Subject: Notification of Class 1 Permit Modification Updates Associated with the Technical Area 63 Transuranic Waste Facility Container Storage Unit of the Los Alamos National Laboratory (LANL) Hazardous Waste Facility Permit, EPA ID # NM0890010515

Enclosures: (1) Class 1 Permit Modification Notification Updates for the Technical Area 63 Transuranic Waste Facility Container Storage Unit, Los Alamos National Laboratory Hazardous Waste Facility Permit

Class 1 Permit Modification
Notification Updates for the
Technical Area 63 Transuranic Waste Facility
Container Storage Unit,
Los Alamos National Laboratory
Hazardous Waste Facility Permit

Figure 5: Storage Building Fire Protection P&ID

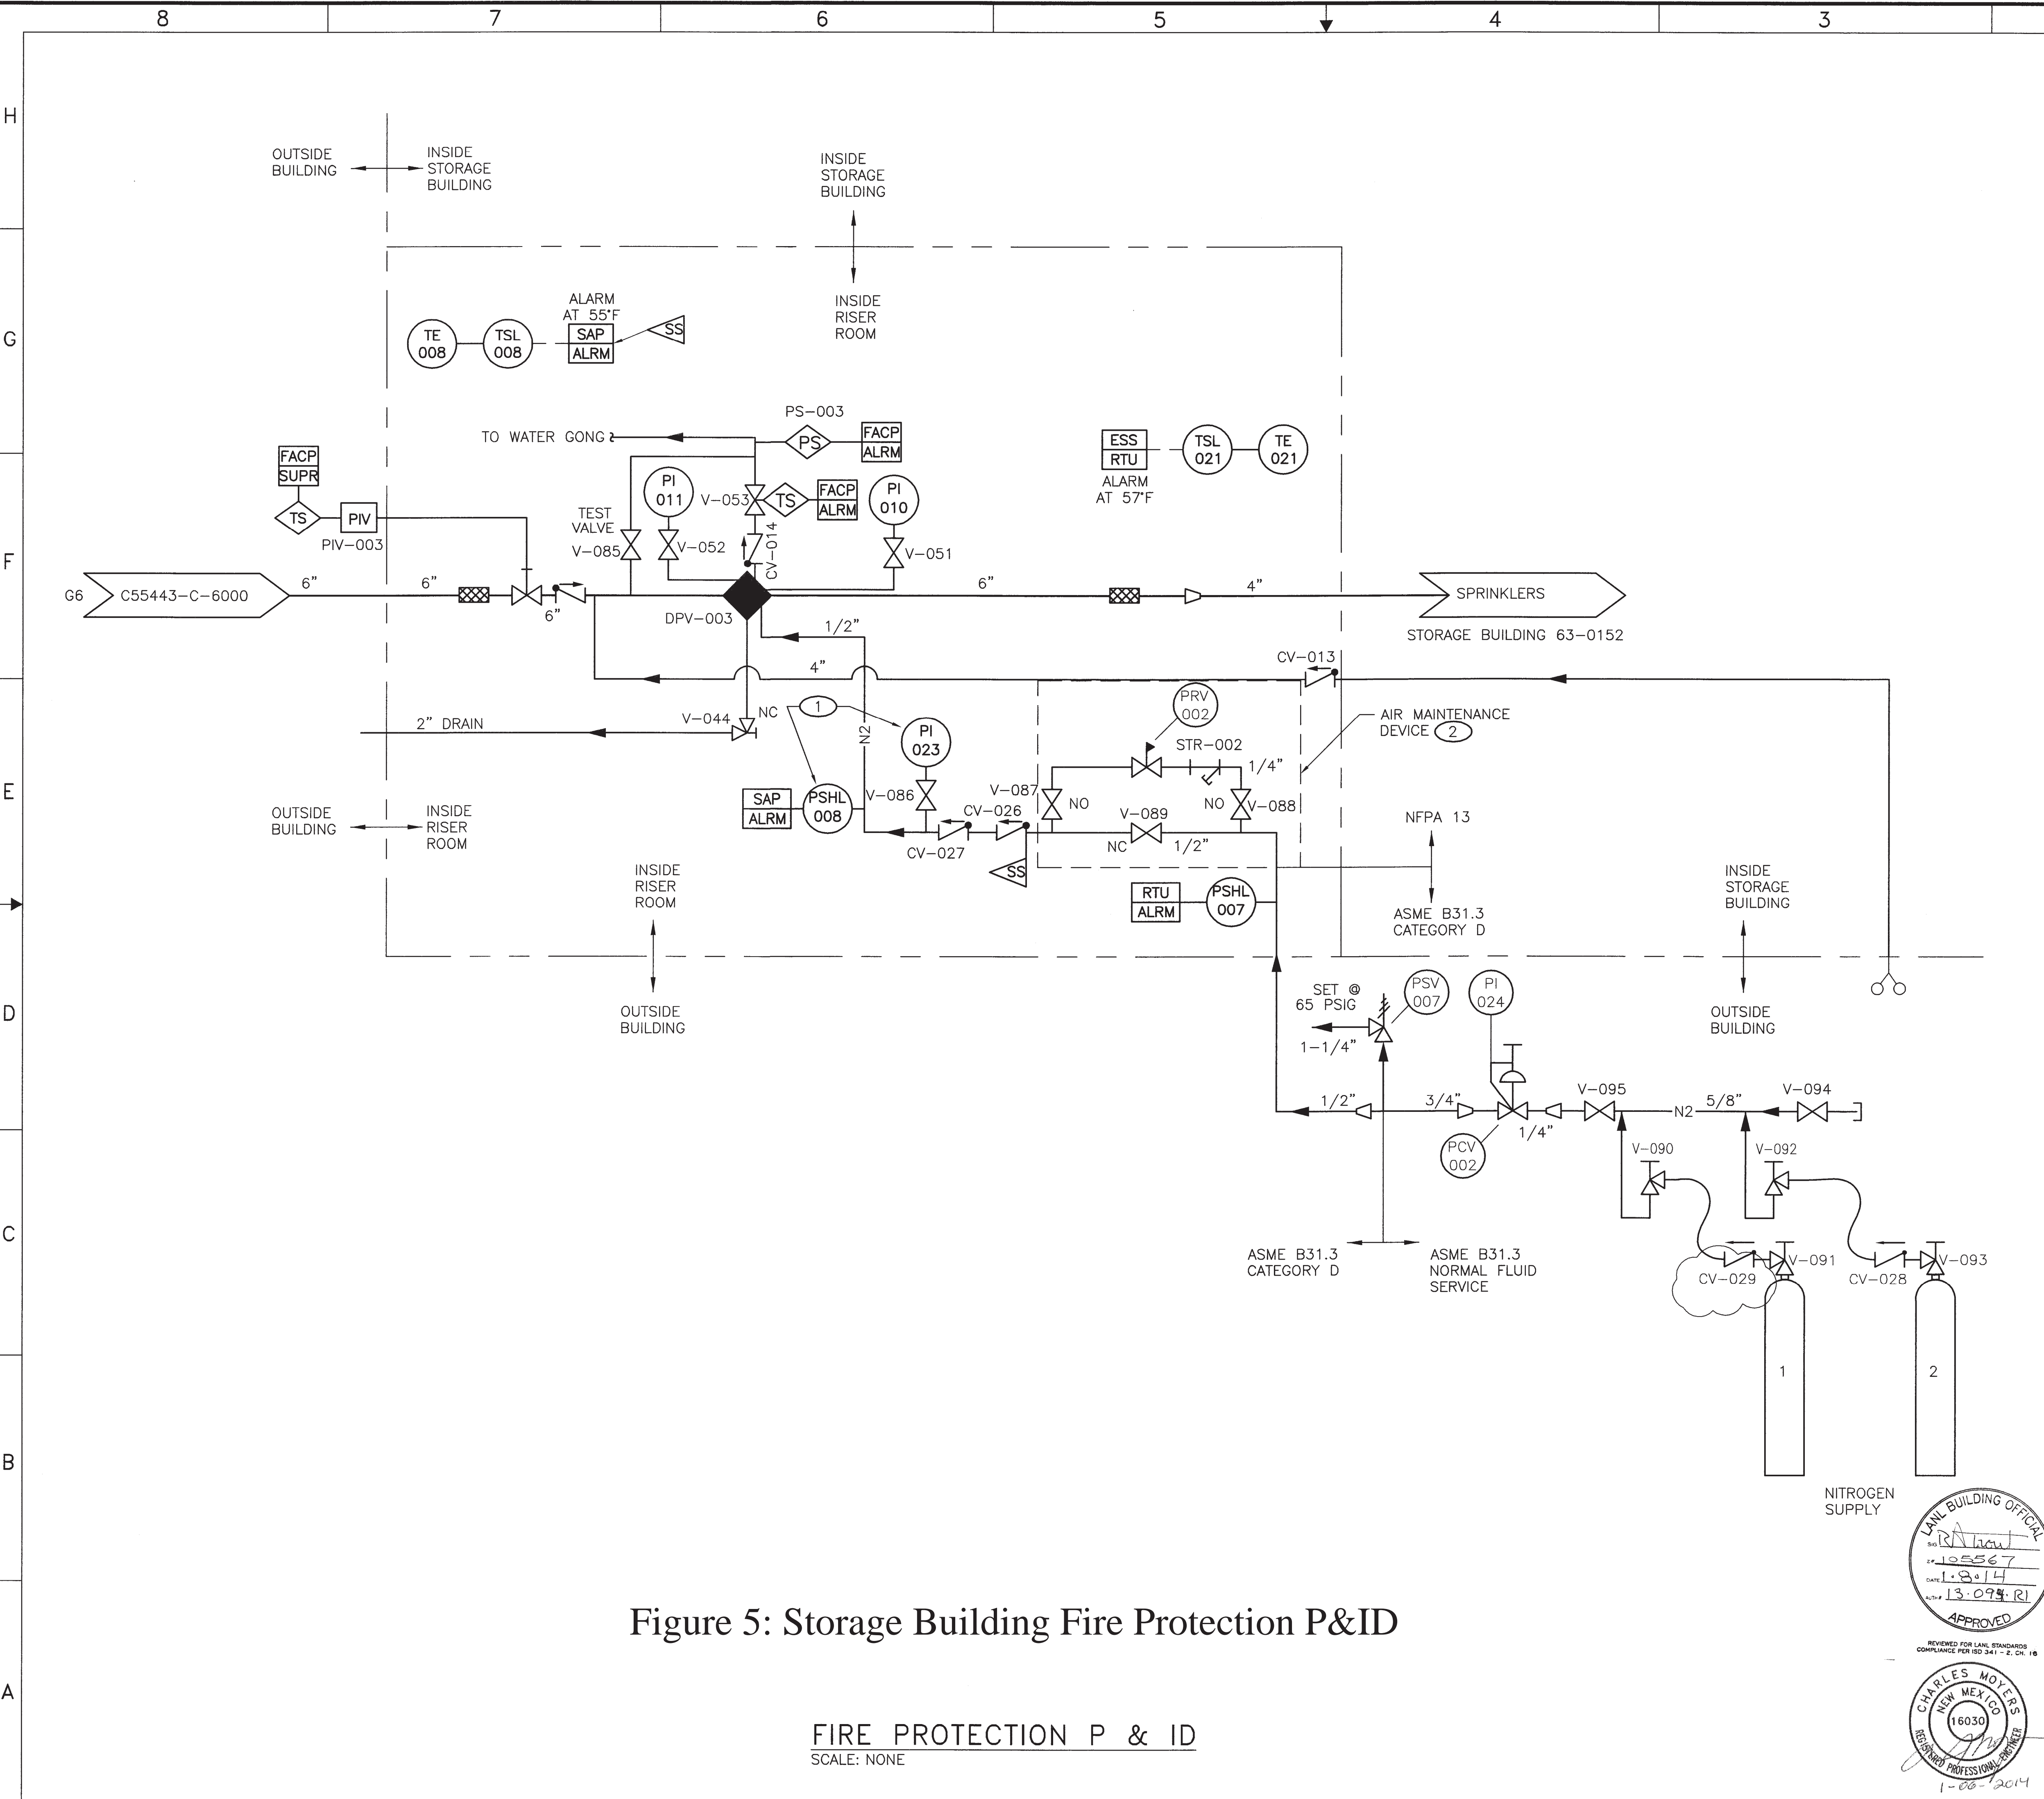
There has been a design revision for the fire suppression system within the storage buildings at the TA-63 TWF involving a substitution in the fire suppression equipment to be used at the facility. Originally, a wet pipe system was described in the TWF Permit Modification Request (PMR) submitted to the NMED-HWB by the Permittees (*Permit Modification Request for Technical Area 63 Transuranic Waste Facility Hazardous Waste Container Storage Unit*, Rev. 3.0, LA-UR-12-24928, October 2012). This has been changed to a dry pipe system. The purpose of the change is to improve firefighting capabilities in the storage buildings and to prevent the possibility of fire water being released from the system in the event of freezing.

The above discussion supports the replacement of the descriptive term “wet pipe” to “dry pipe” for the fire suppression equipment described in Permit Attachment A.6. This design change also affects Figures 2-9, 2-16, 2-17, 2-19, 2-27, and 2-28 originally submitted with the TWF PMR. Those figures described the plan layout of the storage buildings and the original details of the fire suppression water distribution systems. New and revised figures have been included with this submittal in Attachment 1 (*see* Figures 3-14) to support the administrative record for the project by providing the new and revised information. The revisions from the original figures are limited to adding final enclosures for the dry pipe valving to the storage building plan layouts and adding the dry pipe valving components to the existing water distribution piping systems. The purpose of the enclosures for the dry pipe valving will be to contain the valving and heating equipment. The enclosures will not be a structural addition to the storage buildings.

Figure 11: Overall Site Plan

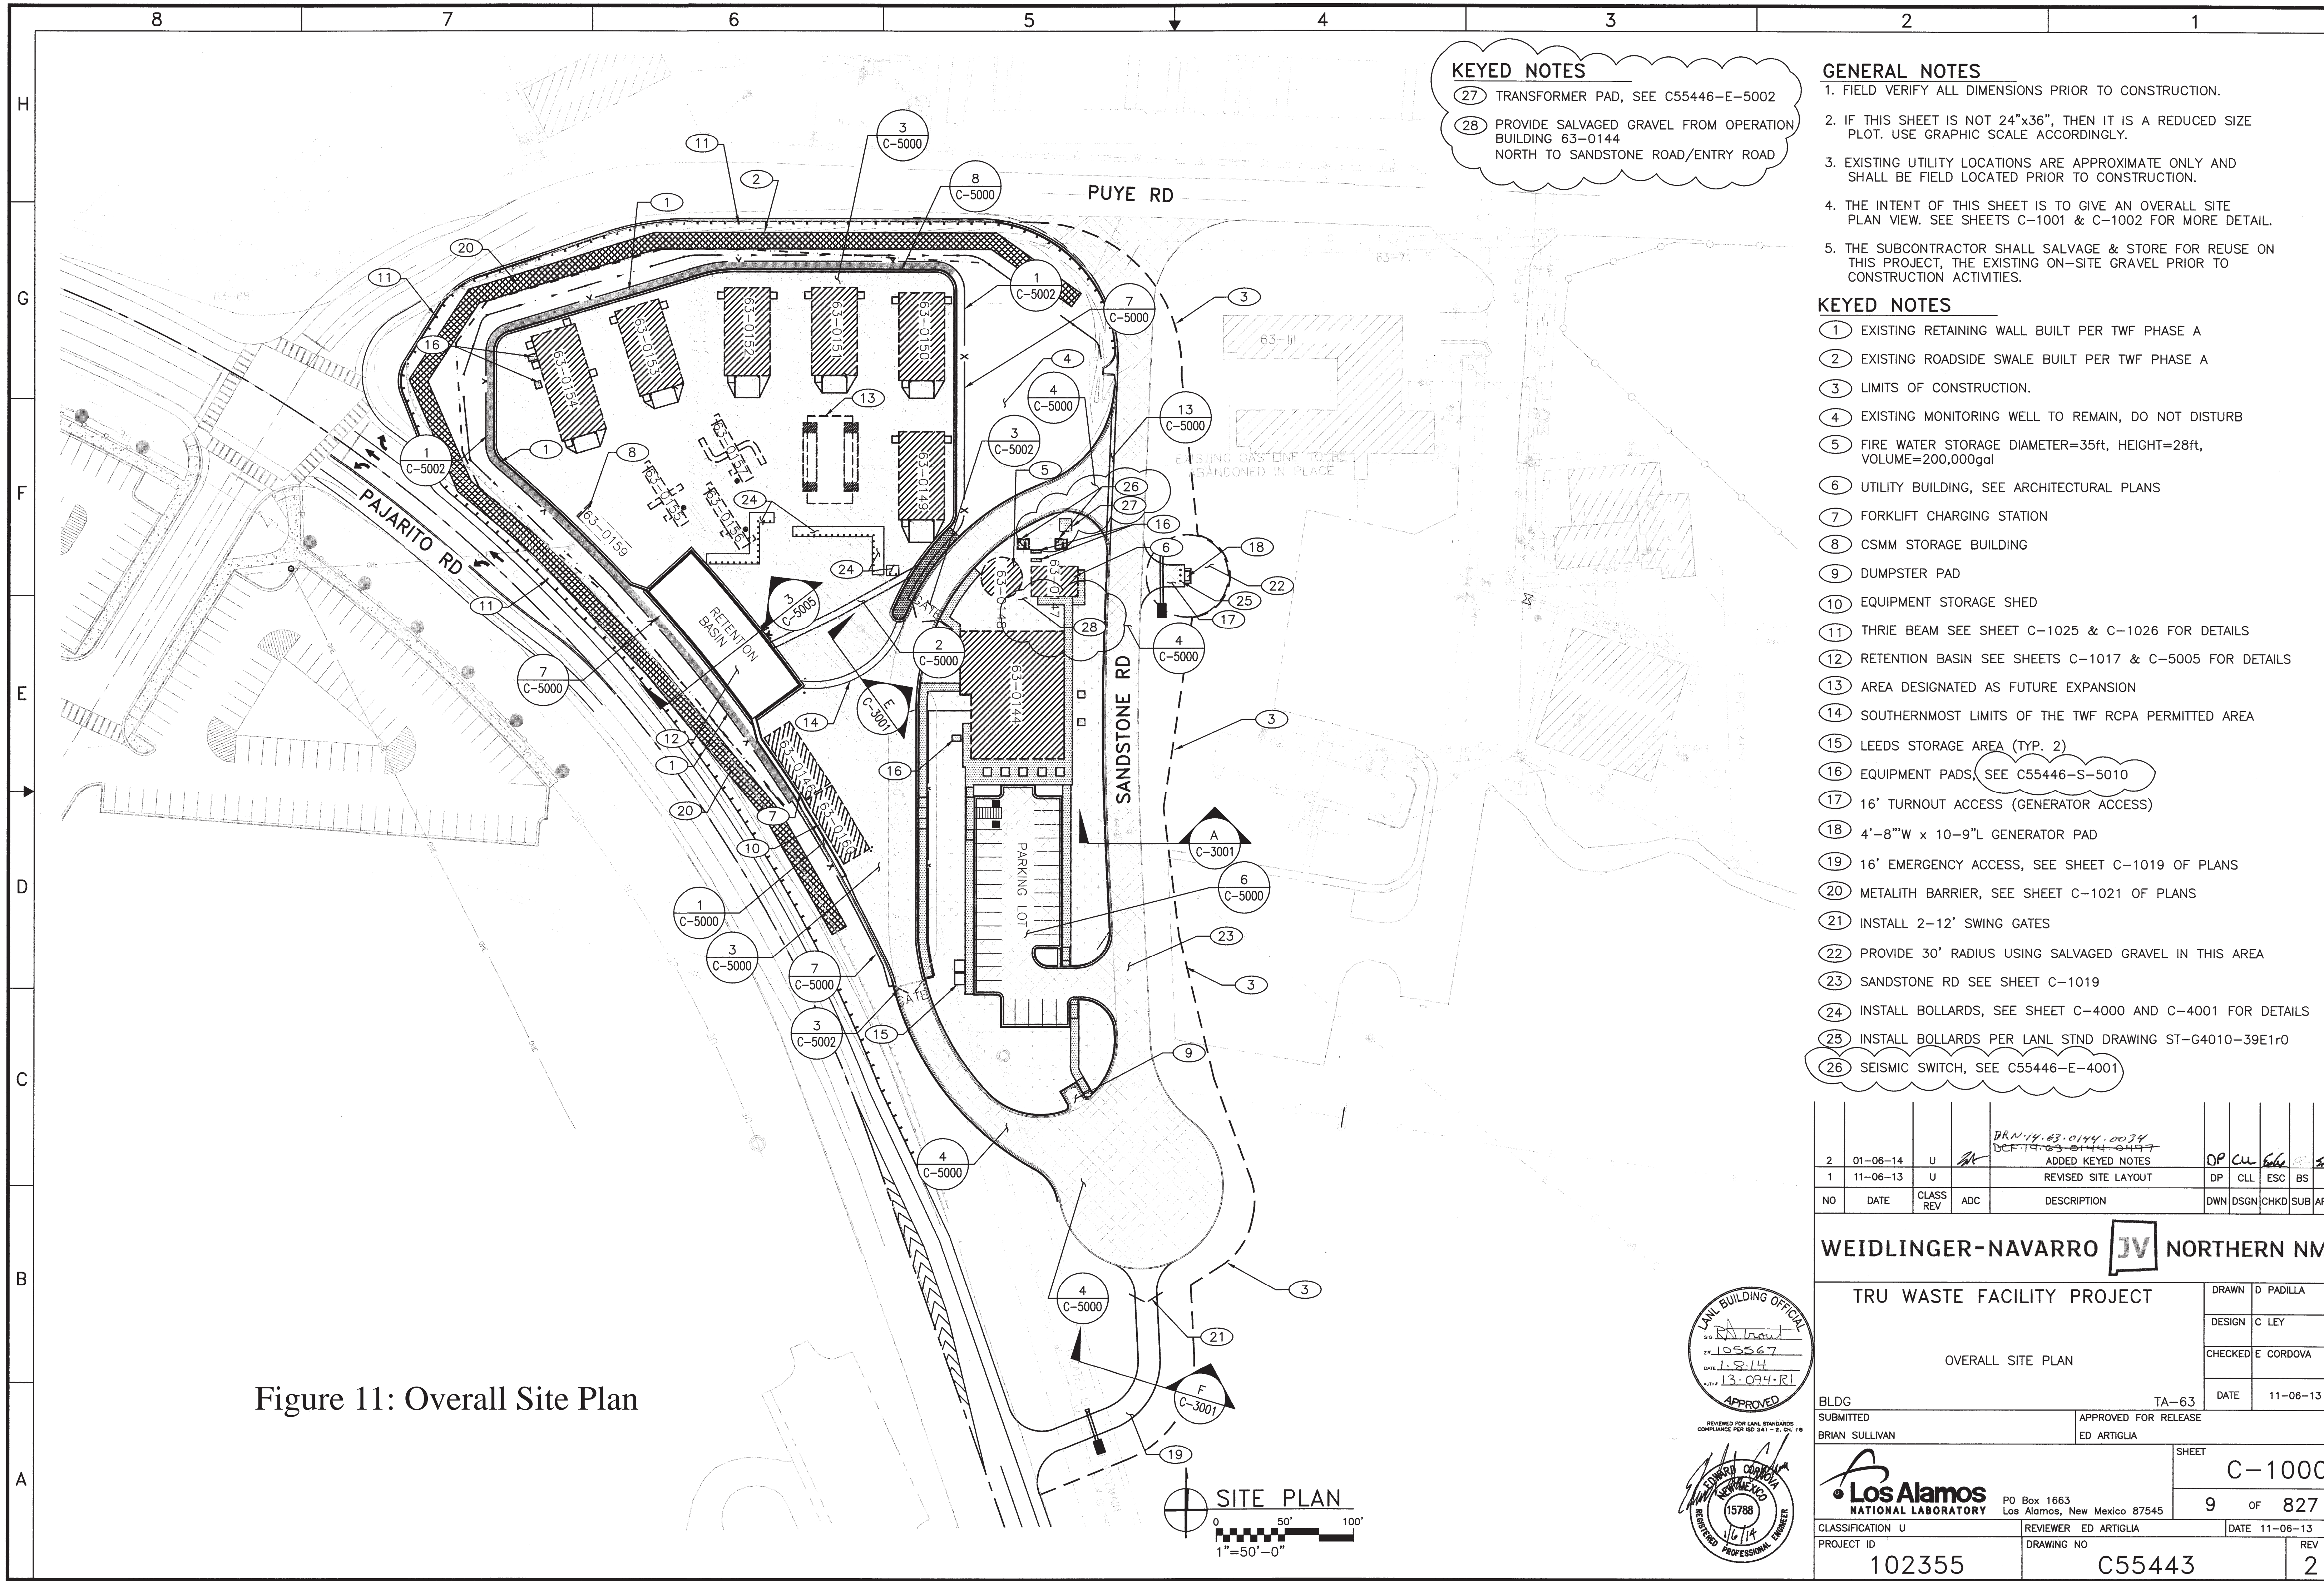
The design plan for the vehicle barriers will involve the placement of a prefabricated steel wall structure (Metalith™) as a perimeter security system along the shoulder of Pajarito and Puye Roads. The Metalith™ is a prefabricated steel barrier unit constructed from 16 and 18-gauge corrugated steel panels that are connected with stainless steel pins, and formed into multiple course assemblies resembling boxes of varying heights, thickness, and shapes. Soil or sand is then used as ballast fill in these assemblies to provide mass and support. These assemblies will be nominally 12 feet high and 12 feet wide at the TWF. They will be situated in a continuous line facing the roads with no gaps or spaces between. The line formed will be approximately 1100 feet long.

The barrier will extend along the northern part of the TWF on Puye Road to near building 63-0150 and also along the western portion of the TWF along Pajarito Road extending to building 63-0160 (*see* Figures 11-13 in Attachment 1 for more detail).
